TECHNICAL BULLETIN

[Issue No.] FA-A-0195

[Title] Changes in the rating plate and the packaging label according to the compliance with EAC [Date of Issue] November 2015

[Relevant Models] MELSEC series

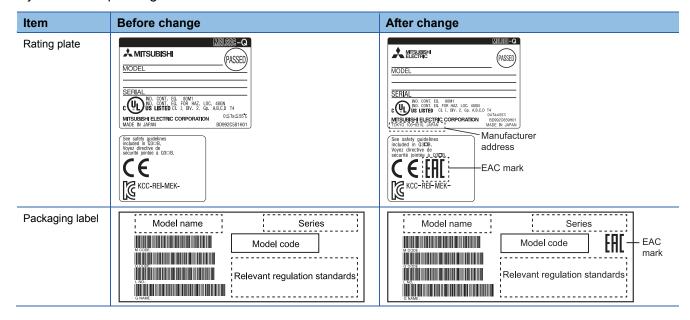
An EAC mark is added to the rating plate and packaging label for EAC certified products. The address of manufacturer is displayed since it has been mandated by the EMC Directive (2014/30/EU) and the Low Voltage Directive (2014/35/EU). The following table shows examples of the change. The contents and layout differ depending on the models.
